DAC3 DX
Firmware Version 2.1 Upgrade Instructions

Figure 1- Top view before installing software kit (note the position of jumper on header P1).

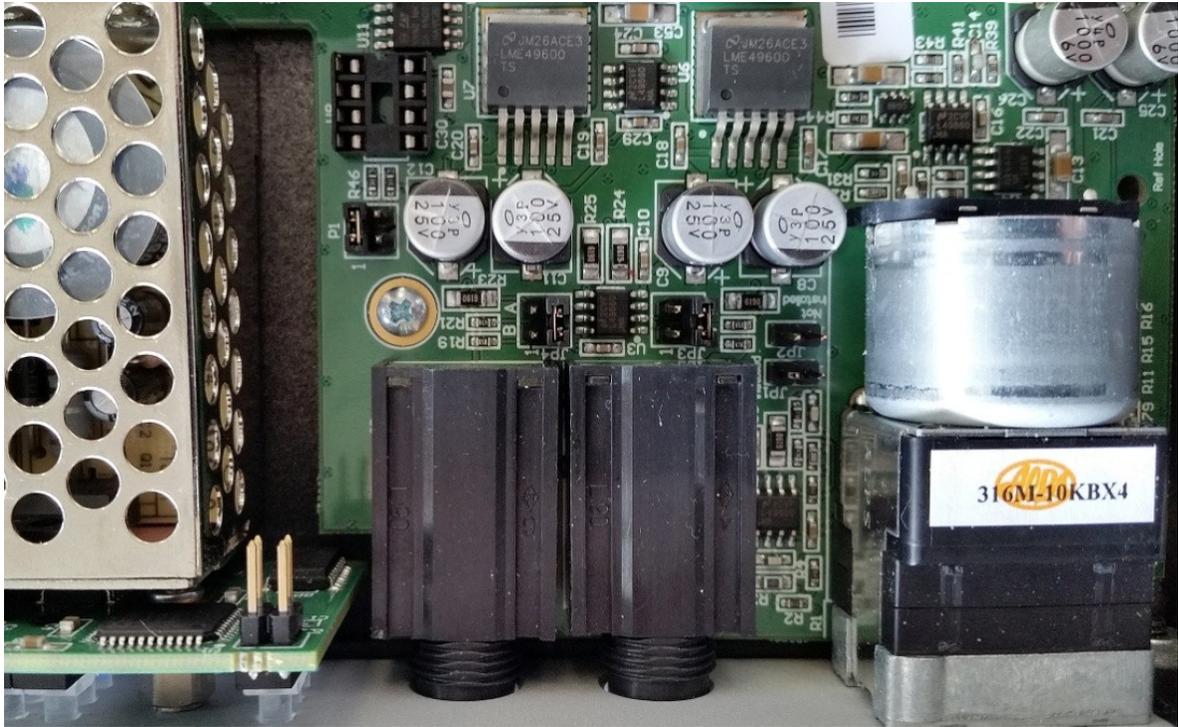
If you wish to revert back to the old software the entire kit can be removed (see Figure 1), but this is not really necessary. The software chip and the jumper on the back of the control board can be left in place. Just move jumper P1 on the main board to its original position, and the original software will be activated. The jumper at P1 selects the on-board memory or the field-upgrade memory chip.

Figure 2 - On the main board, move jumper on P1 to this position.

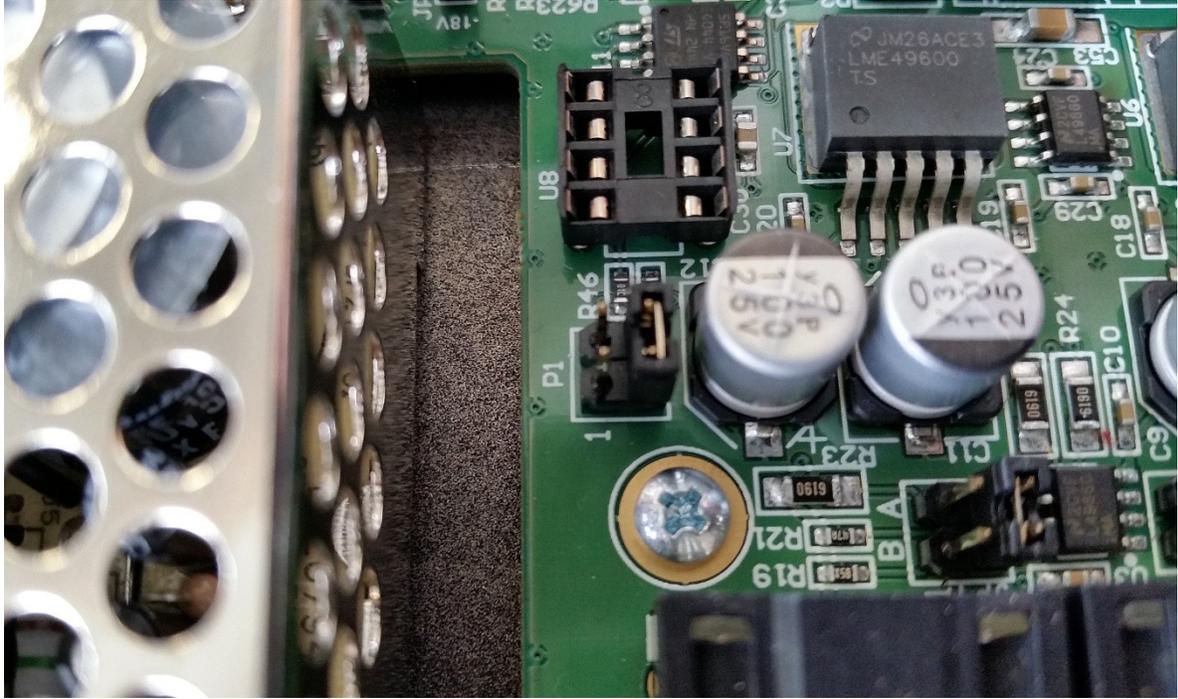
1. Unplug the power cord and all audio cables.
2. Remove the 8 screws on the sides of the top cover.
3. Remove the top cover.
4. On the main board, move the jumper at P1 so that it is on the two pins closest to C12 (see Figure 2).
5. Insert the software chip in socket U8 on the main board with the white line facing the rear of the unit (see Figure 3).
6. Using Figure 3, check the positions of the jumpers (P1 on main board).
7. Using Figure 3, check the orientation of the software chip. The white line must face the rear of the unit. The chip will be damaged if it is inserted backwards!
8. Replace the top cover.
9. Turn the unit on. The M and D5 lights should flash rapidly while the unit is turning on. This indicates that Version 2.1 is installed.

Figure 3 - Finished installation. White line on software chip must face the rear of the unit!

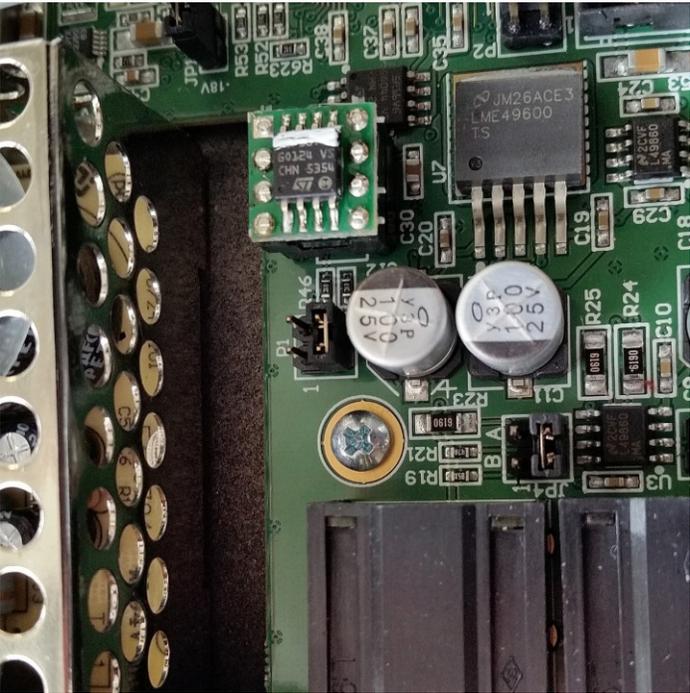
The software chip will be damaged if it is inserted backwards. The white line must face the rear panel of the *DAC3*!
